**MAINE TURNPIKE AUTHORITY**

**ADDENDUM NO. 3**

**CONTRACT**  
**2021.02**

**WATER LINE AND UTILITY**  
**VAULTS**

STA. 2360+02.55 - DETAILS III

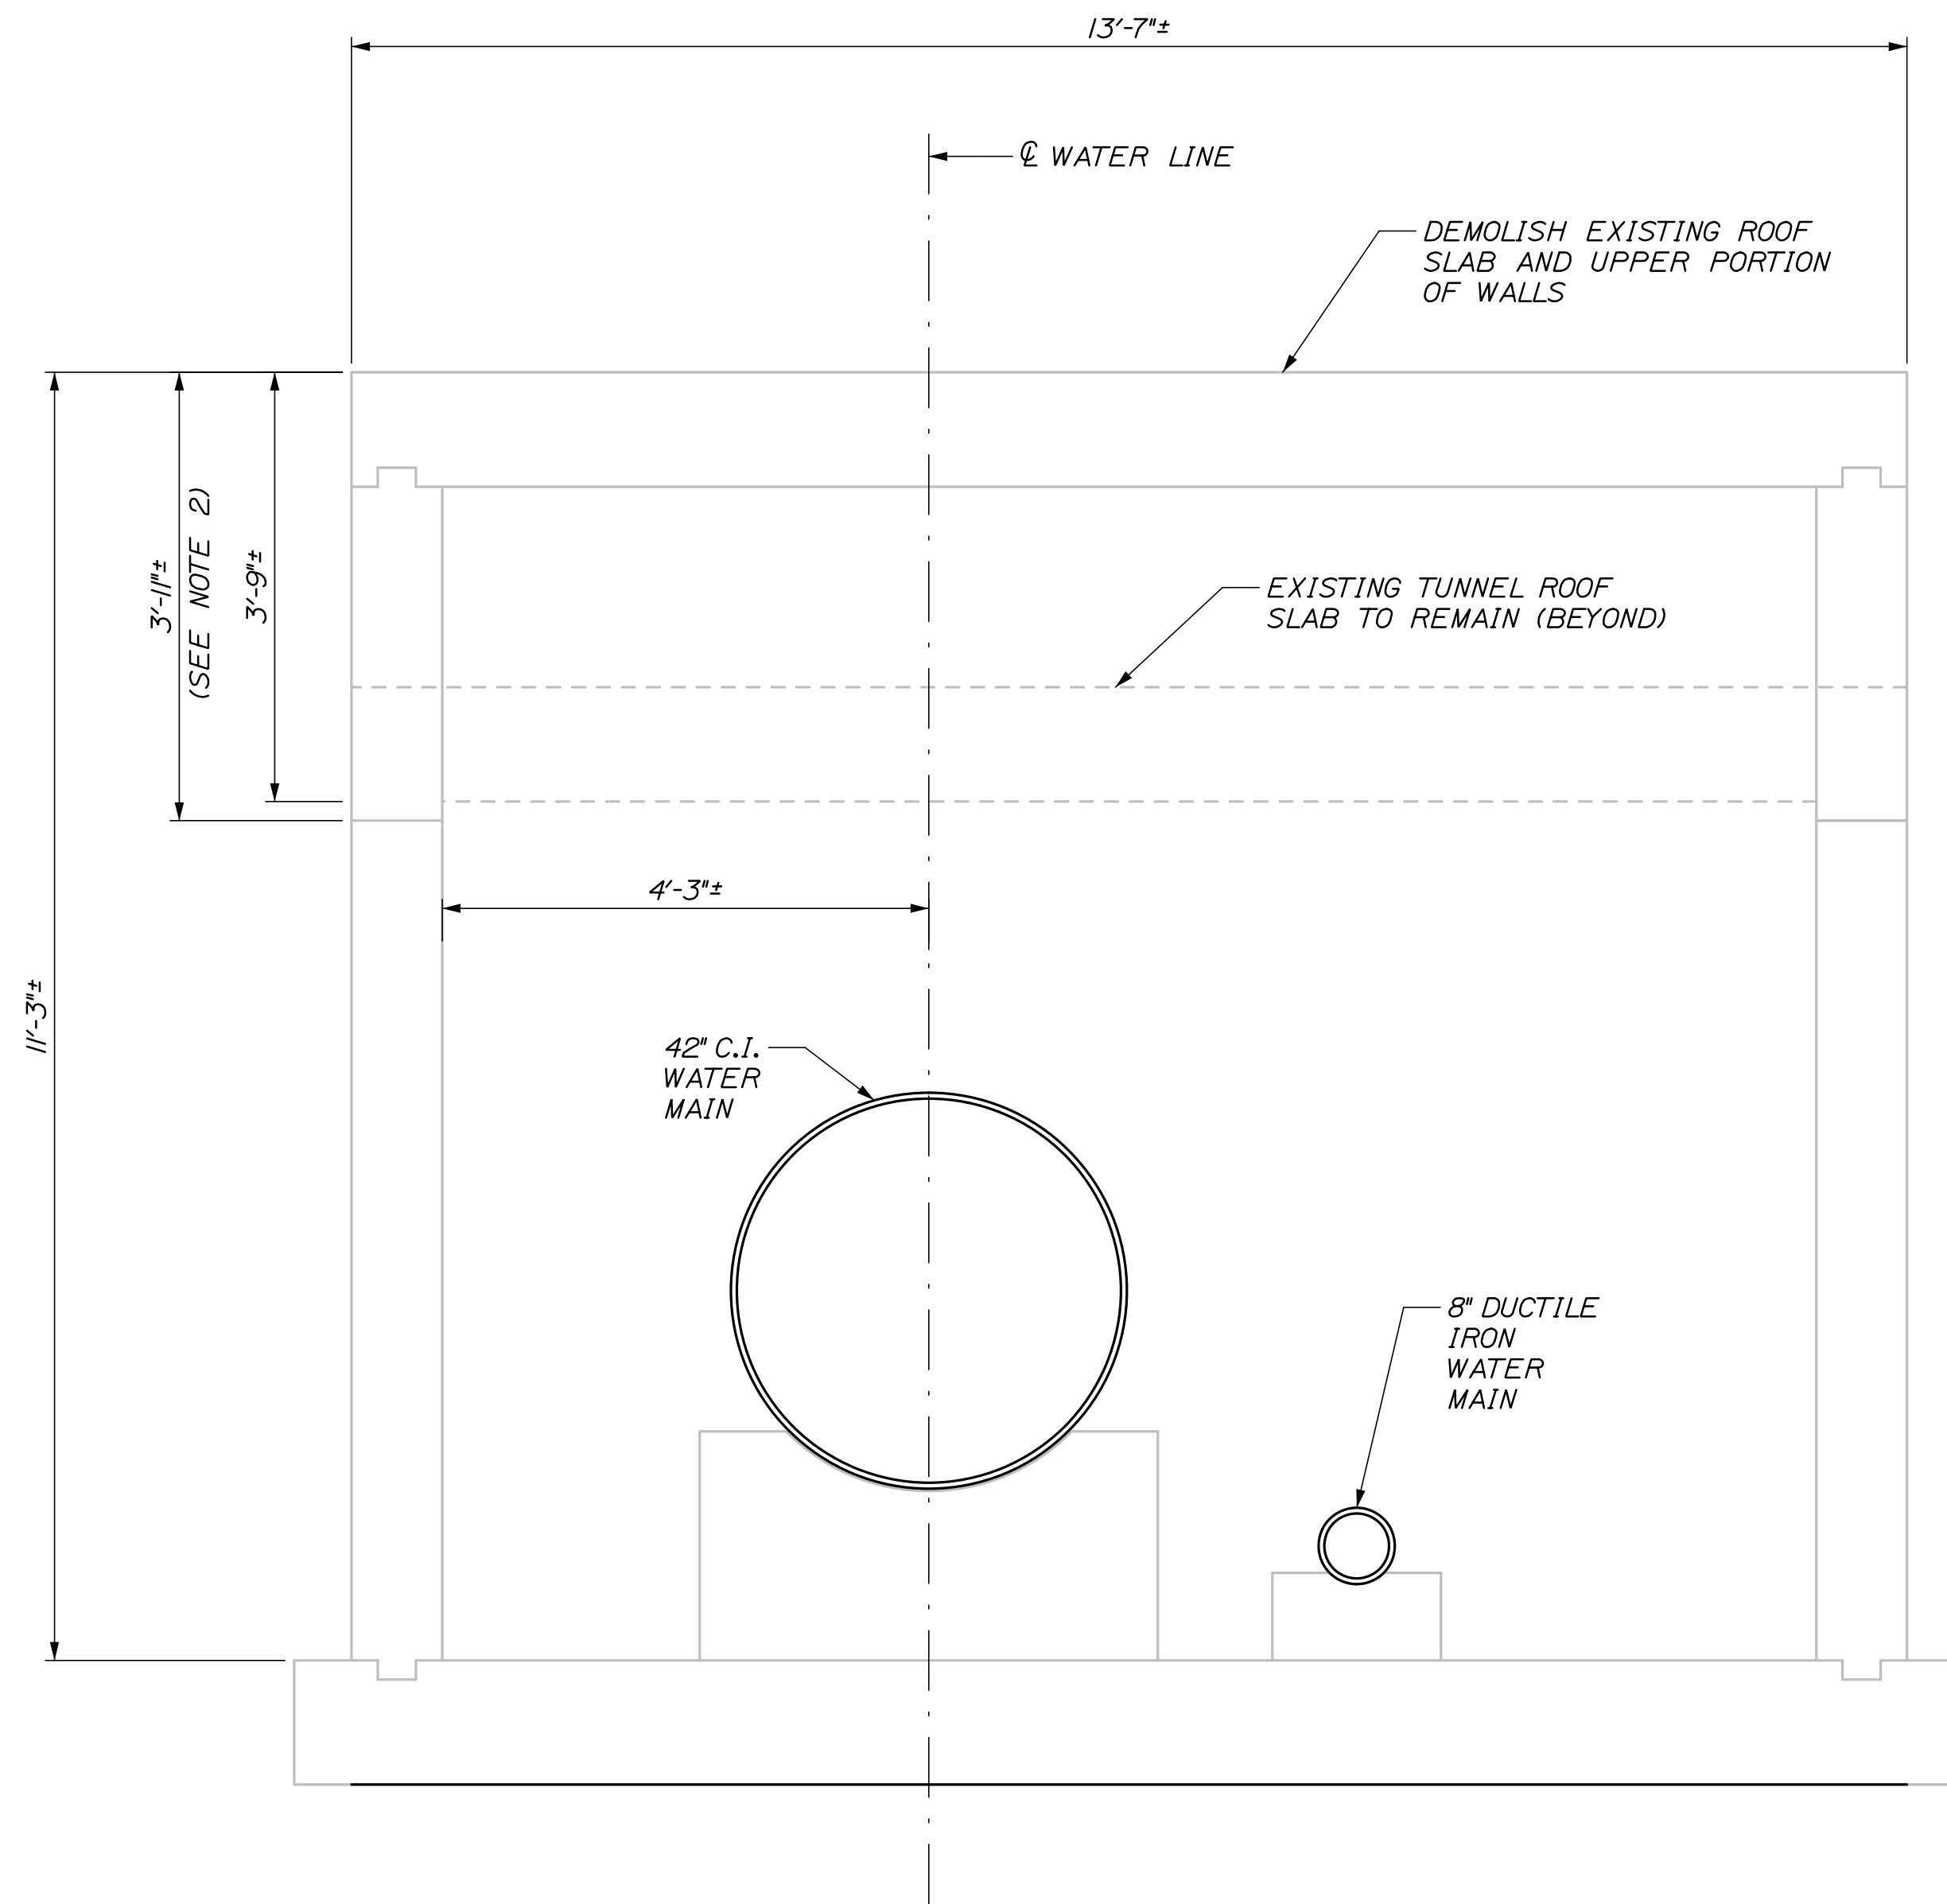
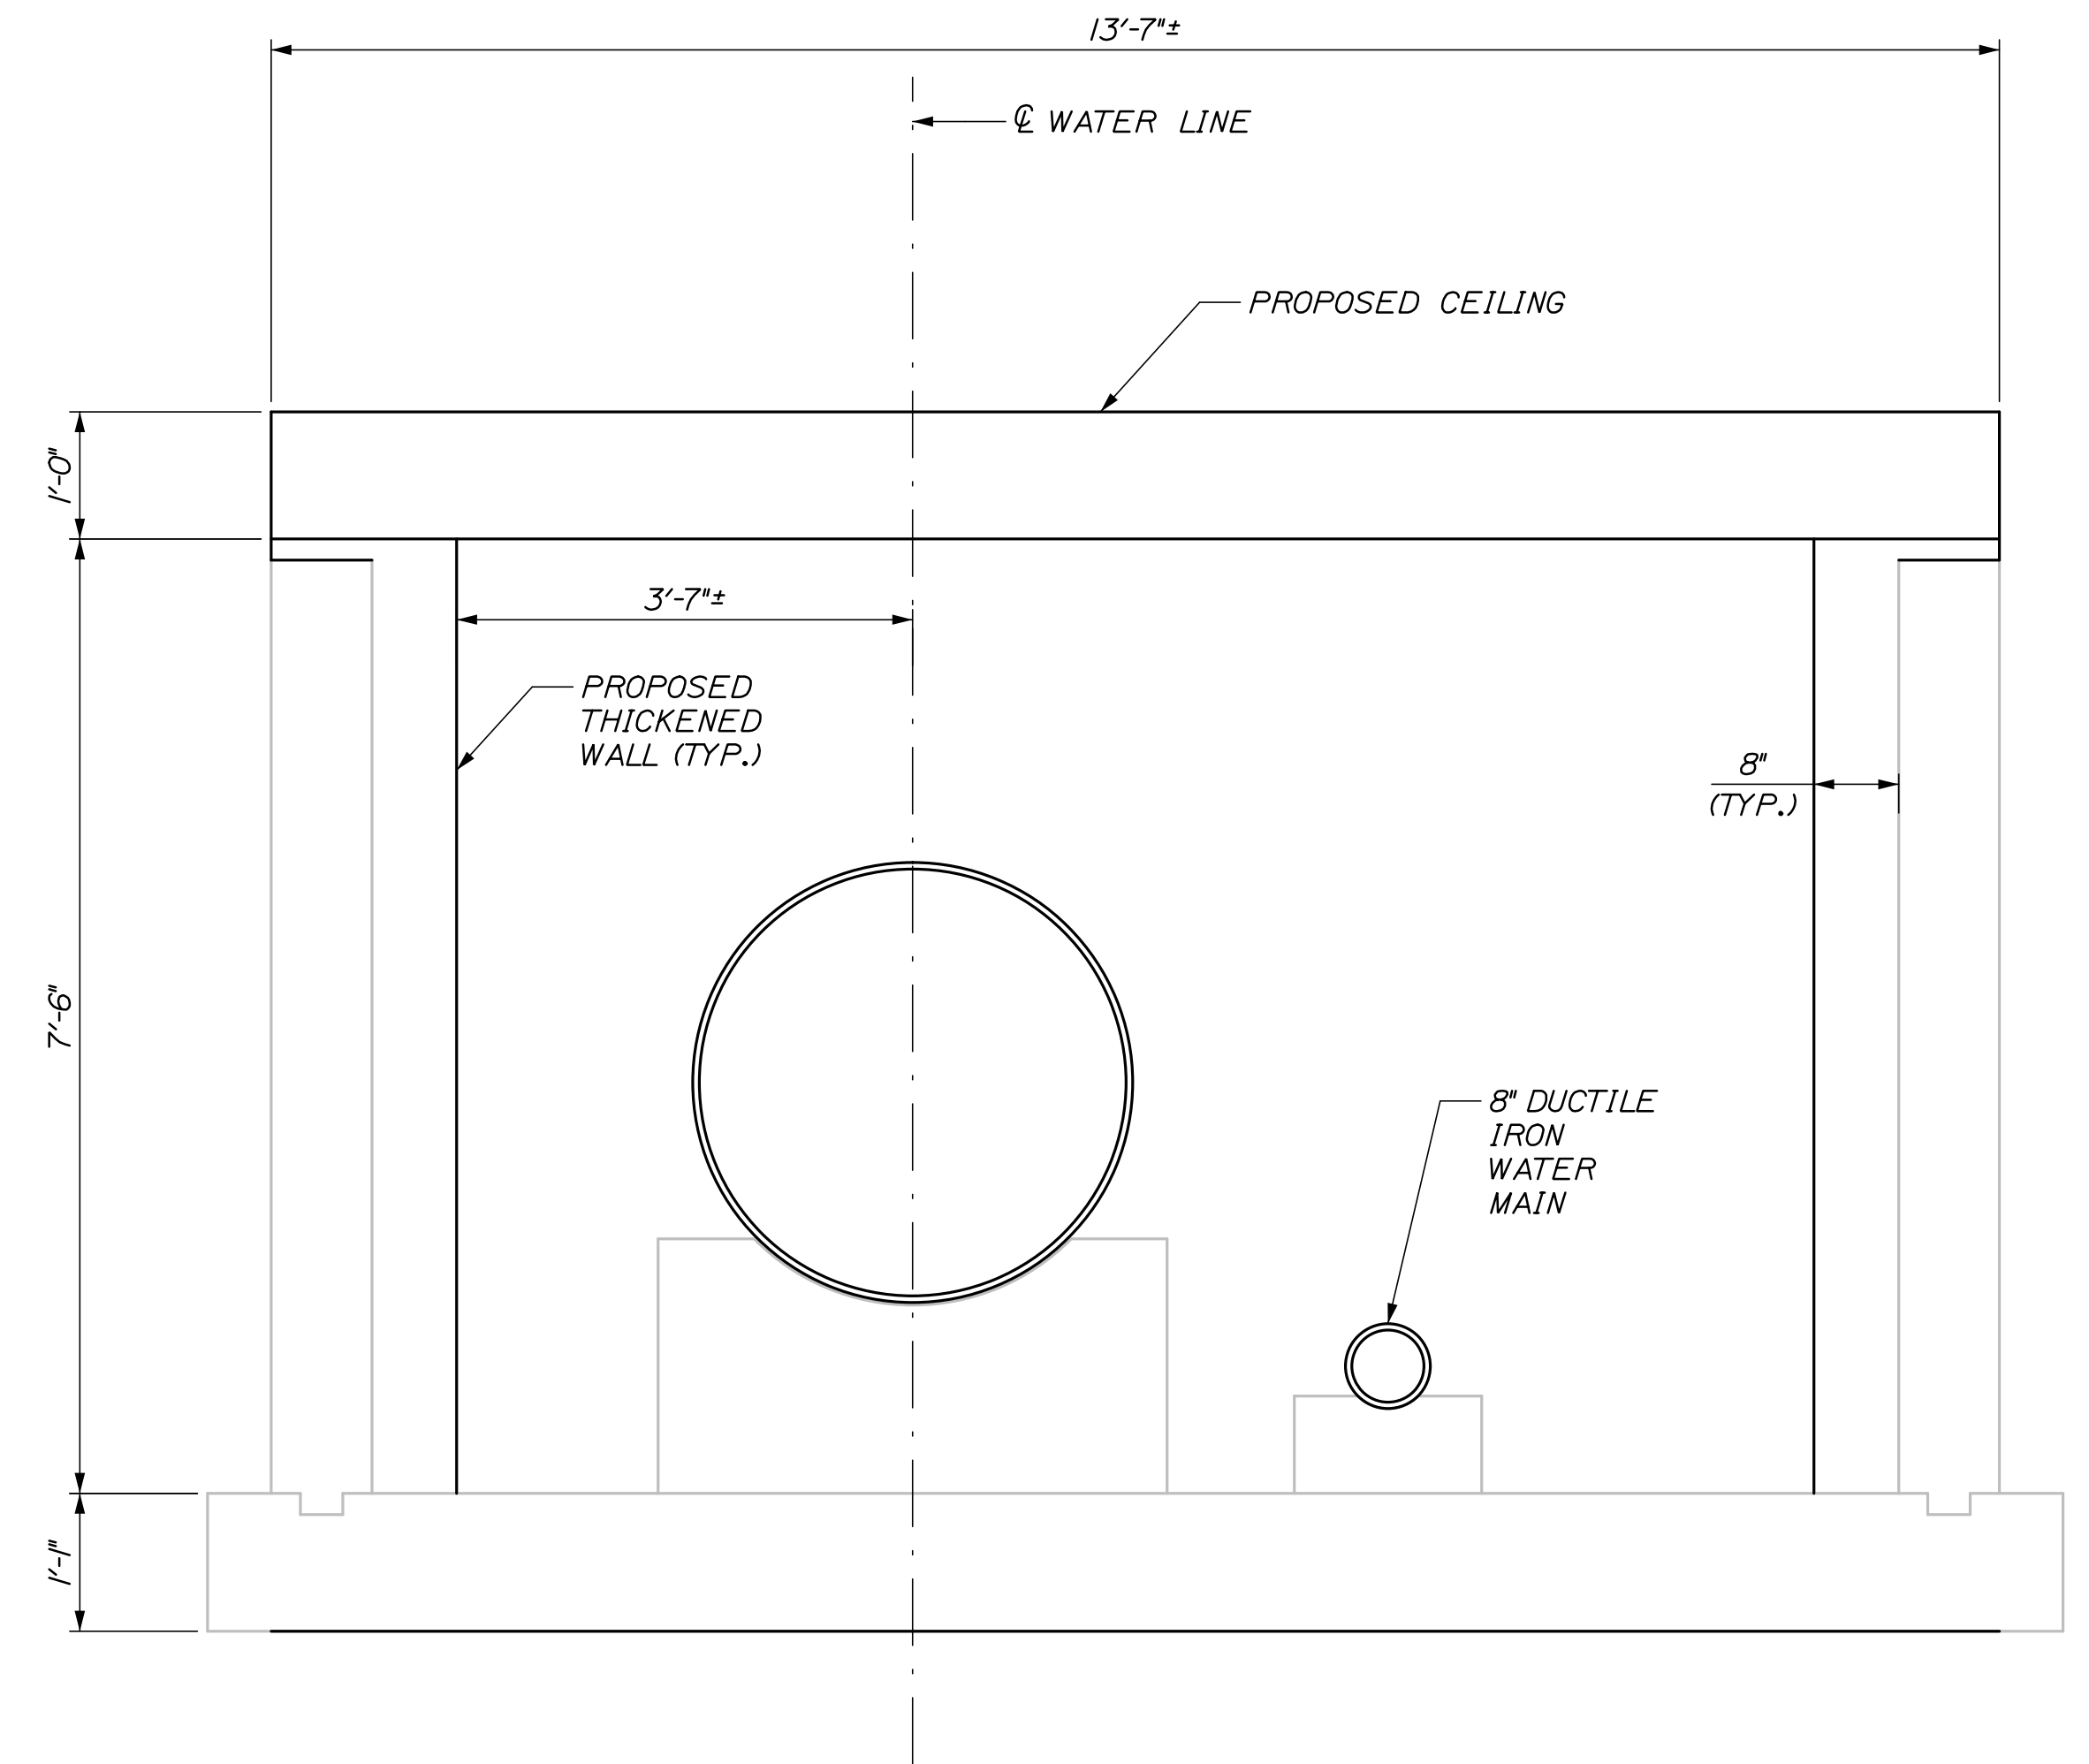
Scale:				Designed by:			
AS NOTED				<b>HNTB</b>			
No.	Revision	By	Date	CONSULTANT PROJECT MANAGER: Dale A. Mitchell, P.E.			
1	ADDED SHEET	BRG	06/21	By	Date	By	Date
				Designed	BRG 03/21	Checked	JDW 03/21
				Drawn	ERB 03/21	In Charge of	TRC 03/21

**8" PIPING MODIFICATIONS**

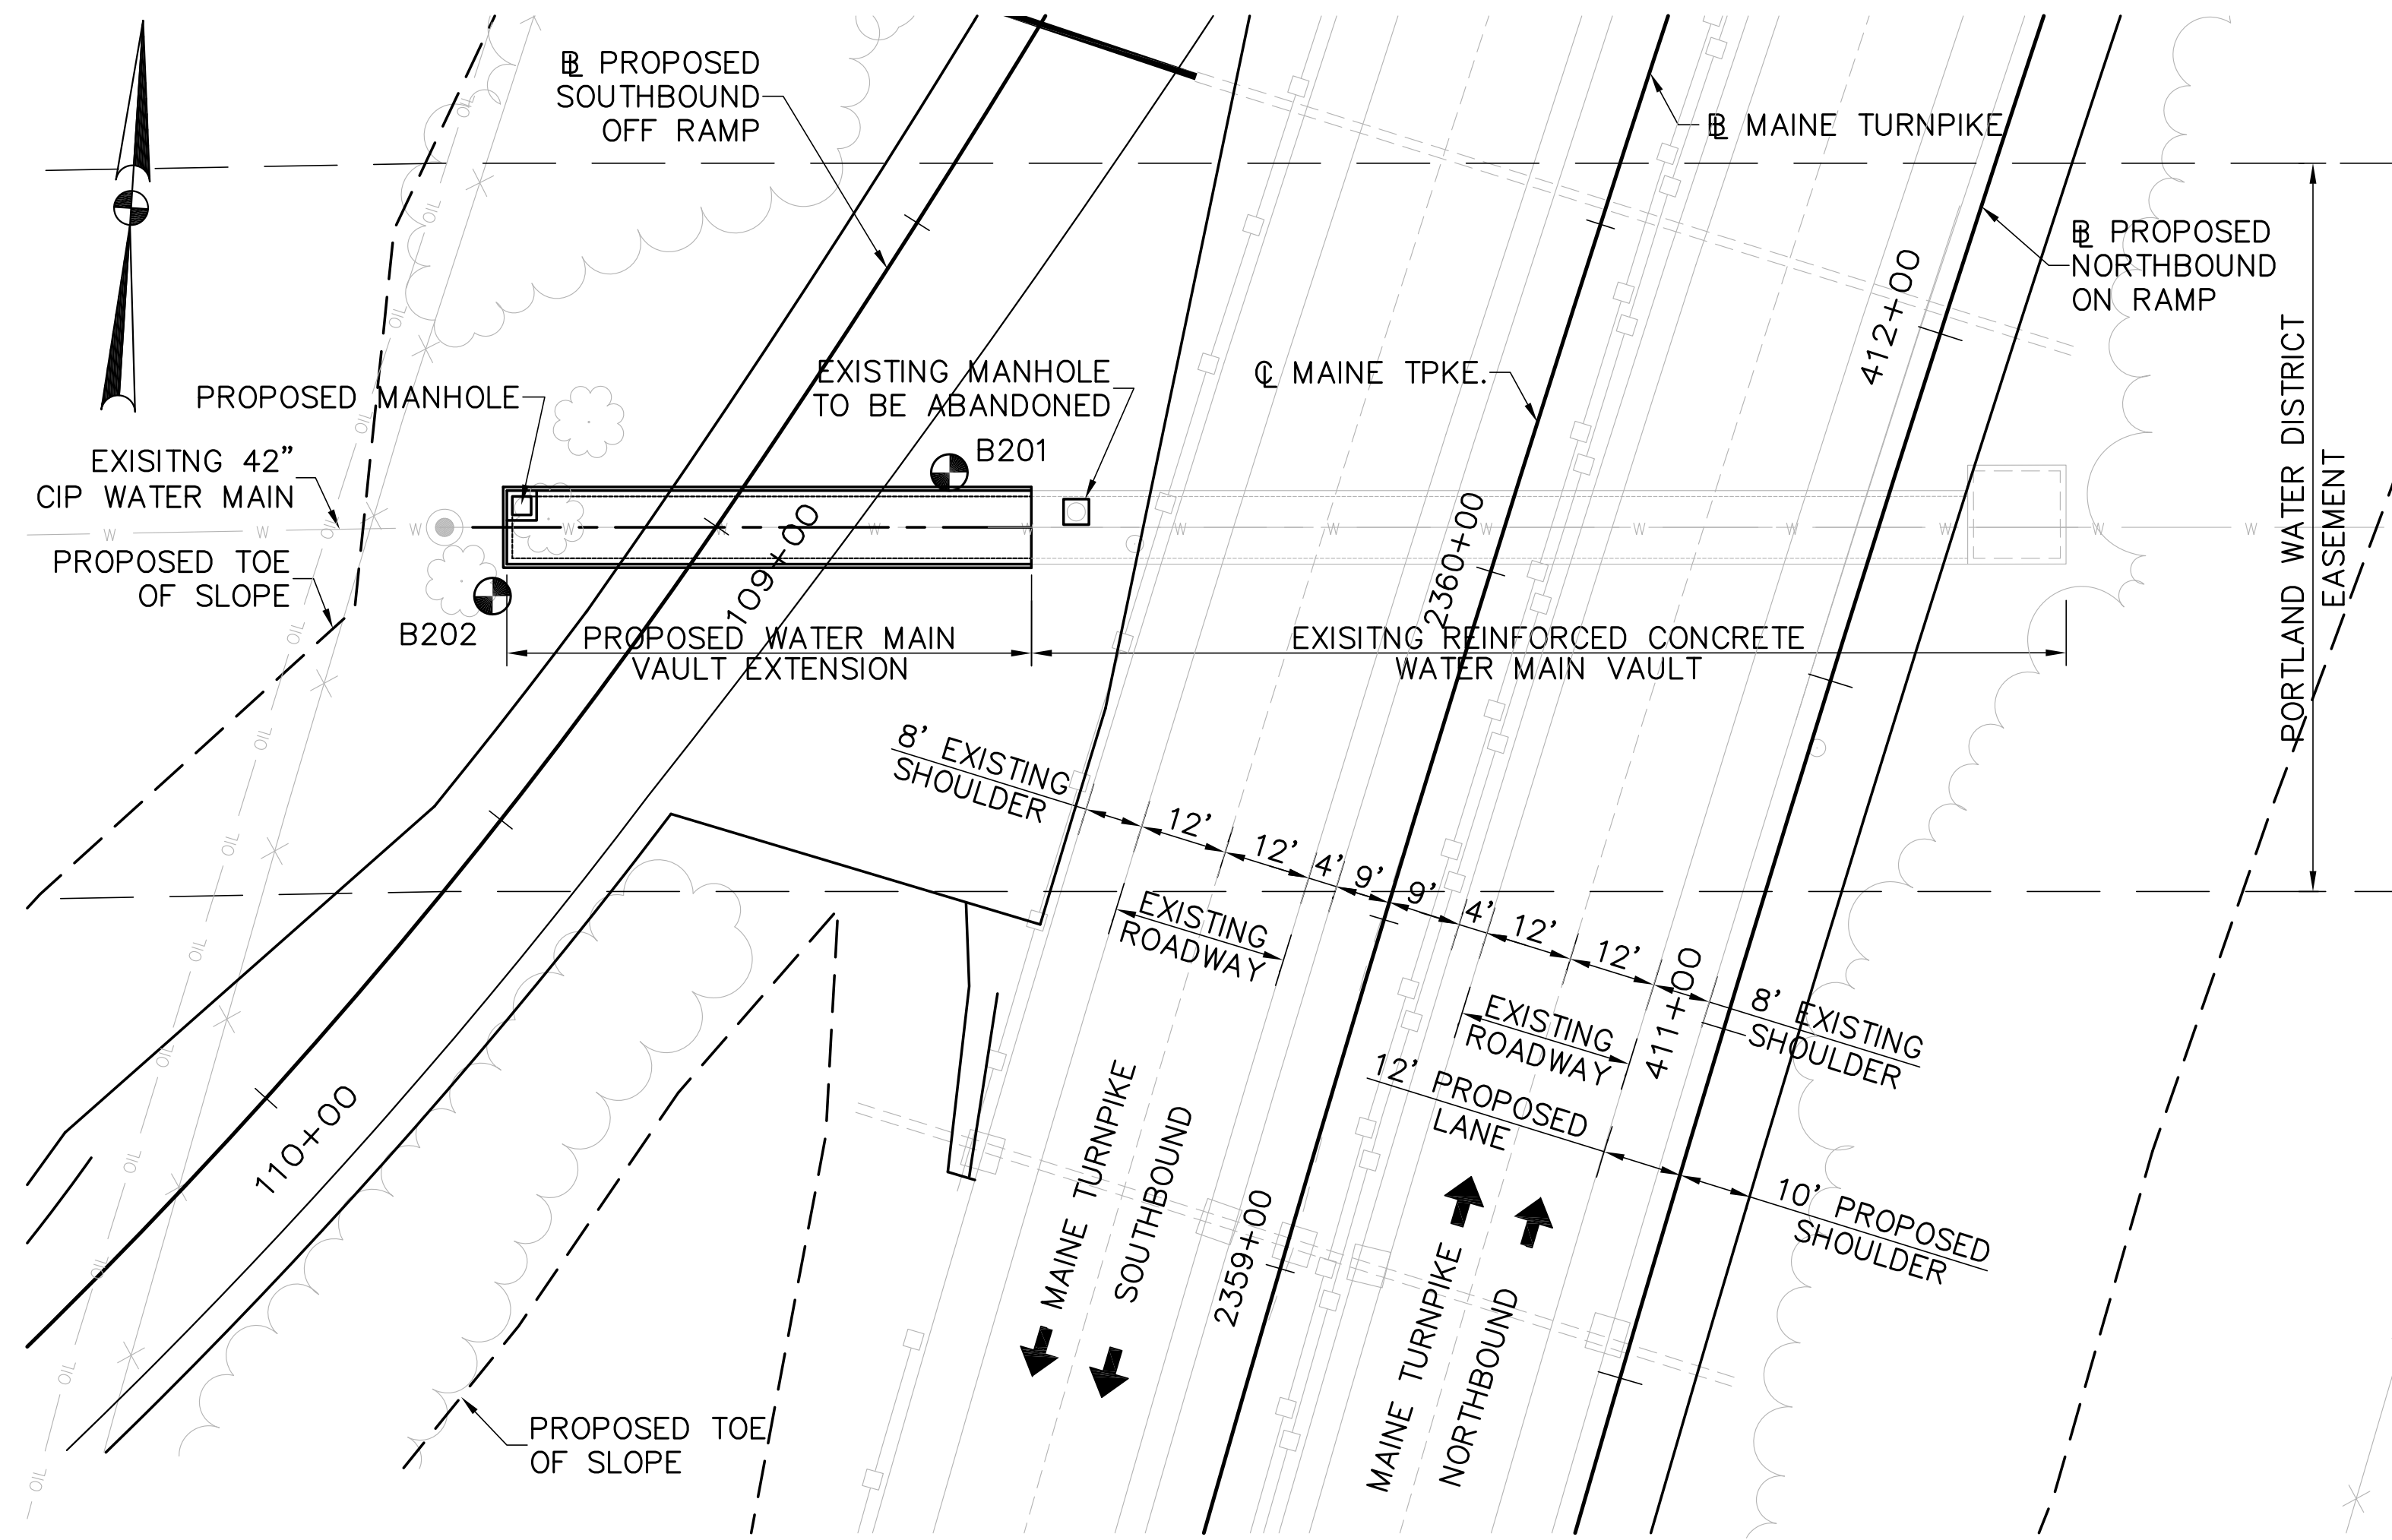
- Plan sheet 1, Index of Sheets, is revised to include additional 8” cast iron pipe removal and abandonment at the Station 2360+02 Vault. See attached.
- Plan sheet 2, Estimate of Quantities, is revised to add Item 827.38 Vault Pipe Modification. See attached.
- Plan sheets 26 through 31, Structural Plans, are revised and plan sheet 29 added to include thickened wall construction and updated vault dimensions based on field conditions. See attached.
- Plan sheet 35, 8” Piping Modification, is added to the plan set. See attached.

This sheet added to Plans in Addendum #3.  
See clouded notes for required work.
